**ADDENDUM  
NO. 03**

**May 22, 2026**

**Kalamazoo Public Schools EL SOL School  
1428 Baker Drive  
Kalamazoo, MI 49048**

This Addendum consists of Pages ADD 3-1 through ADD 3-3 and TowerPinkster Addendum No. 03, dated May 21, 2026, consisting of 5 pages, additional Specification Section 07 21 00 Thermal Insulation, and 20 drawings.

SHEET NUMBER  
C 102

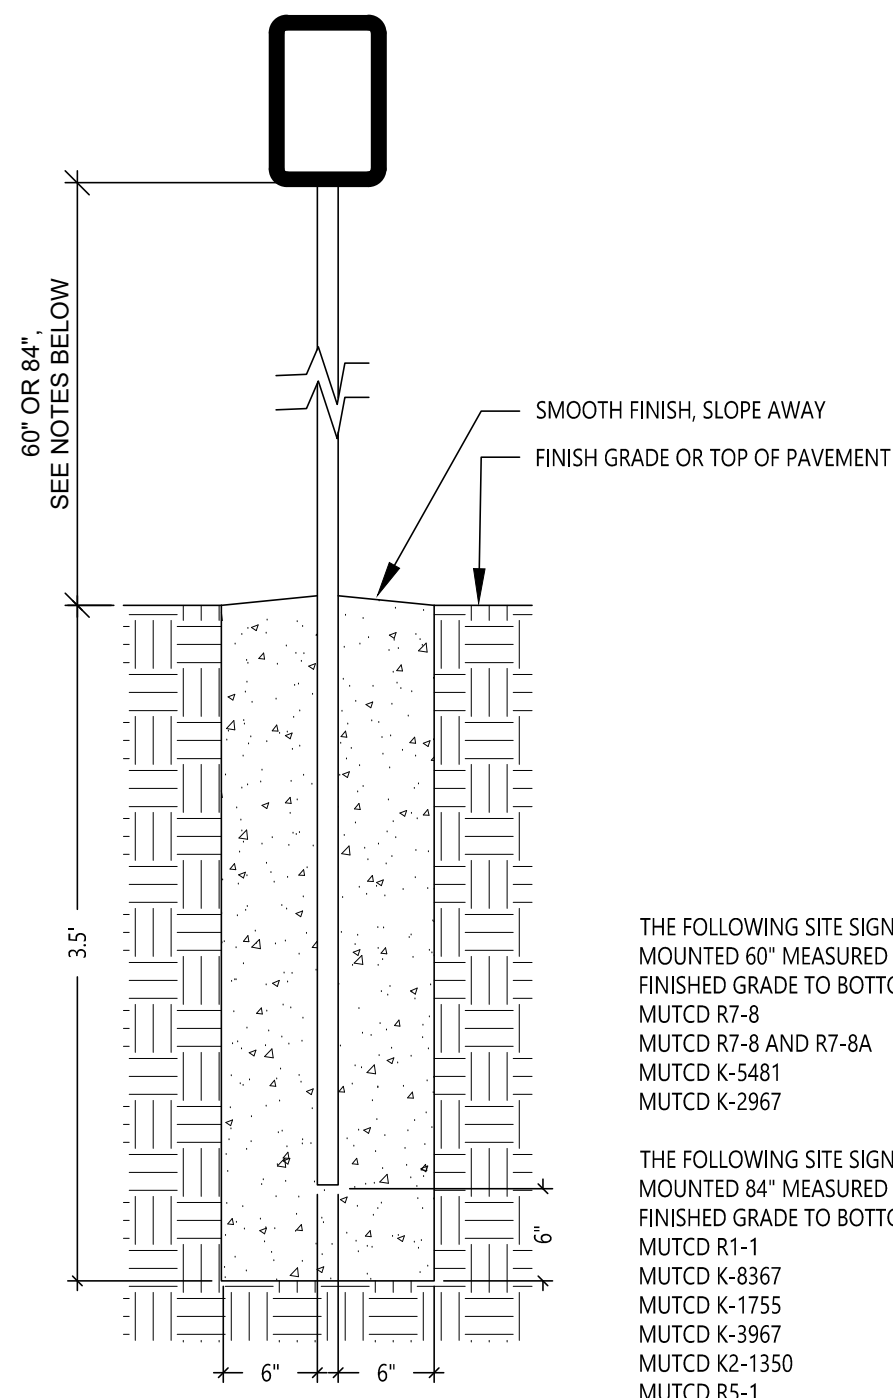
Refer to Sheet(s): C 102

Keynote pointing to the area surrounding the log seats has been revised to "2.4" [crushed fines].

7.3  
C 203 BOLLARD  
NOT TO SCALE

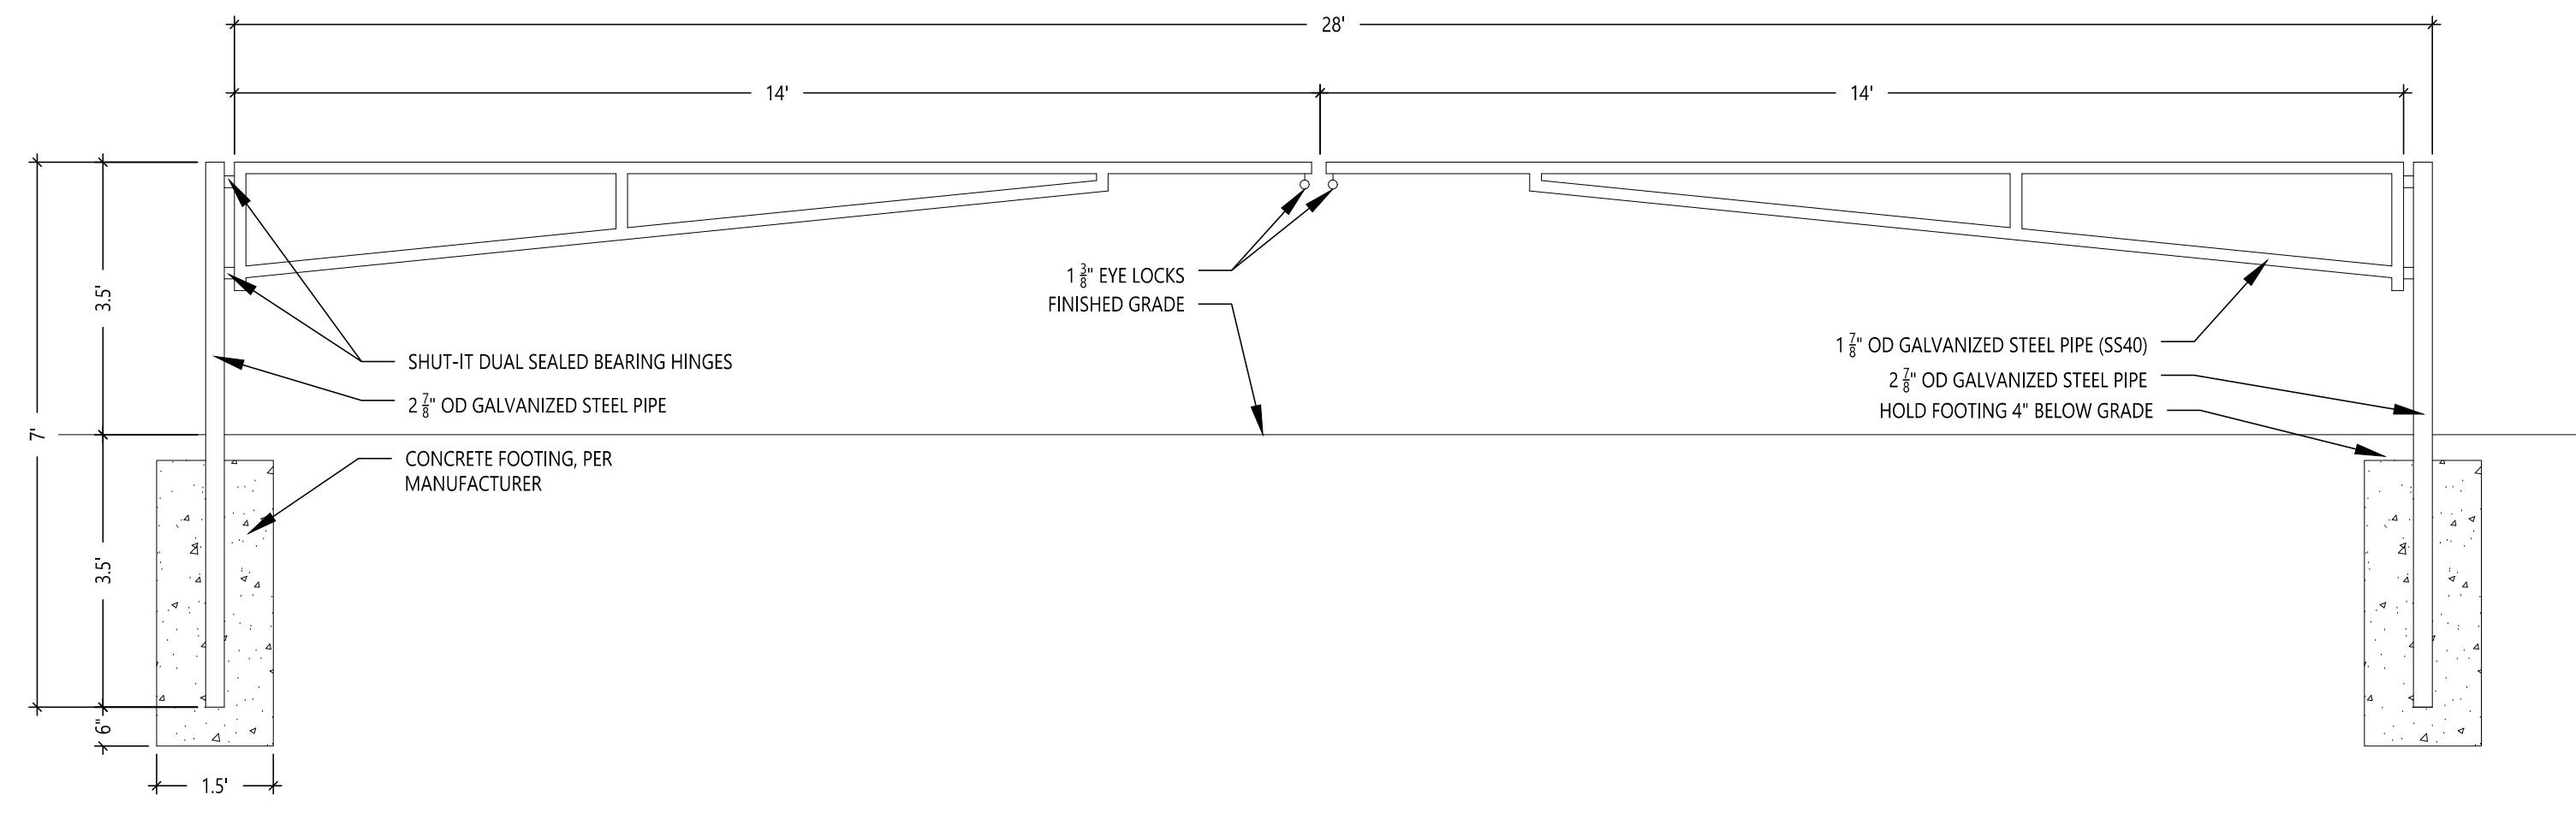
Refer to Sheet(s): C 203

Bollard detail 7.3 / C 203 has been updated to call out SCH. 40 to match callout in specification.

**35A WALL DETAIL**  
A 331 1 1/2" = 1'-0"

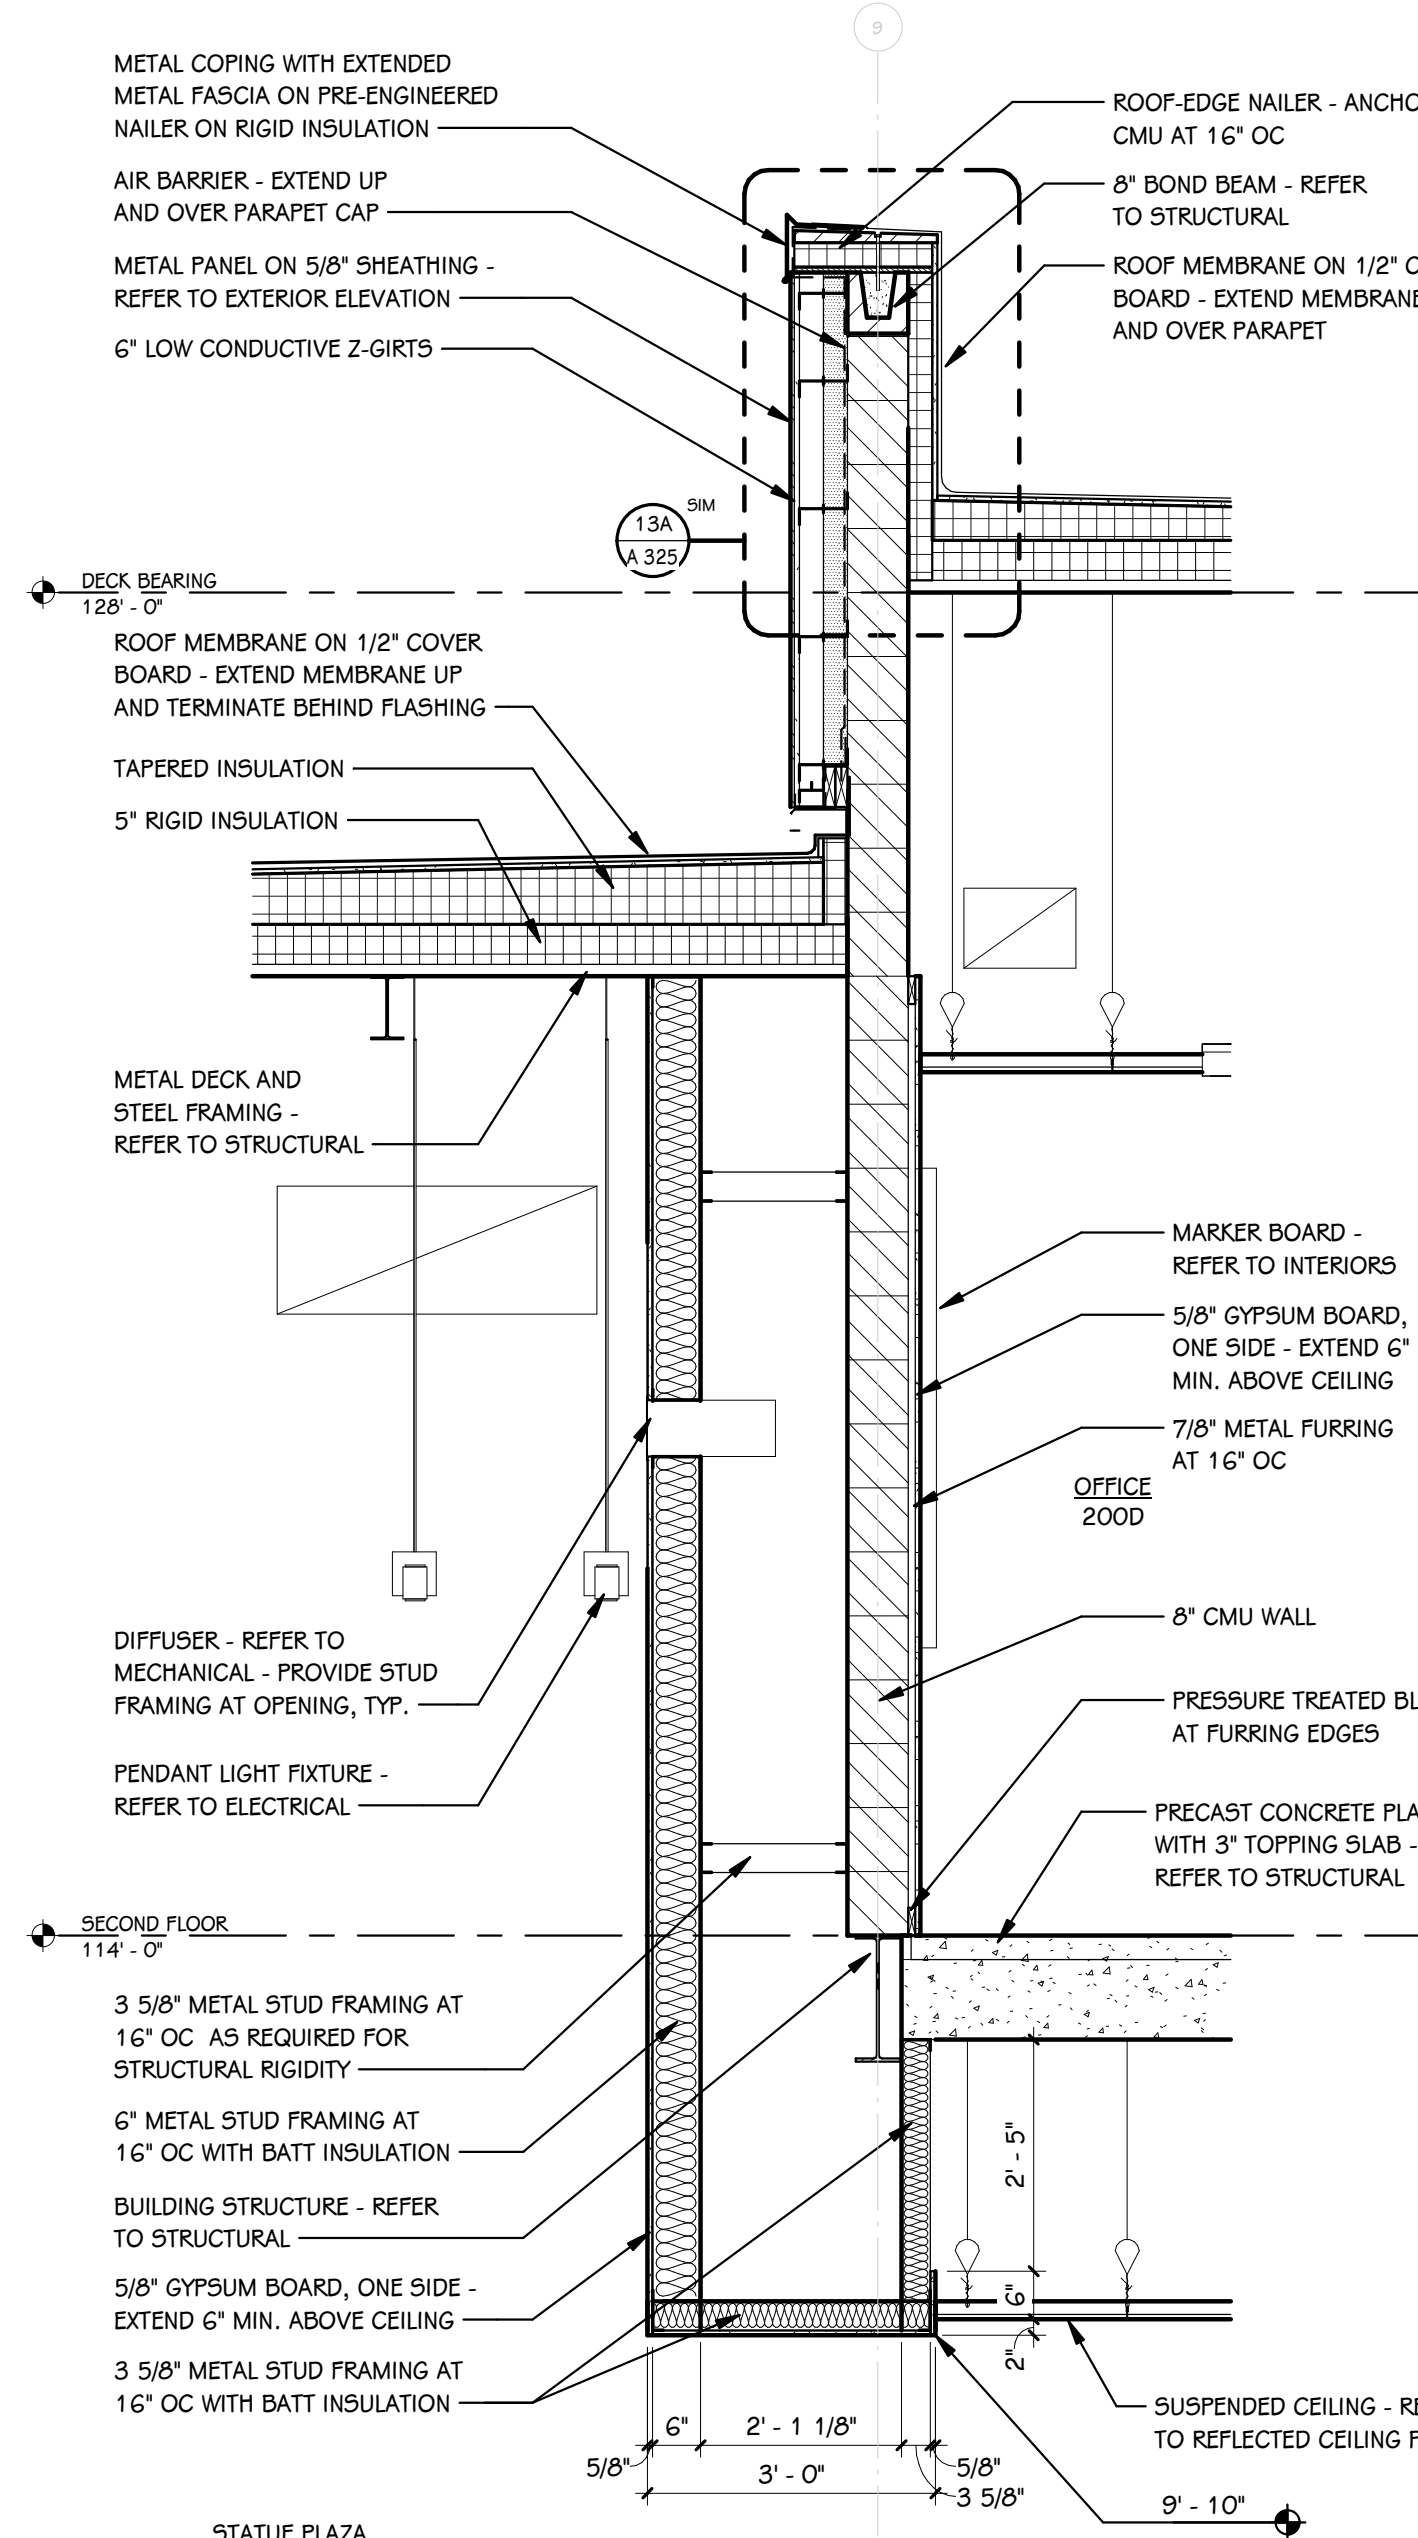
Refer to Sheet(s): A 331

Updated detail 35A/A331 to call out for an air barrier to be installed over the Densglass. Use Georgia-Pacific StoGuard VaporSeal to coat the Densglass. Use detail 35A/A331 as a typical detail for ALL Densglass behind metal panel to receive an air barrier.
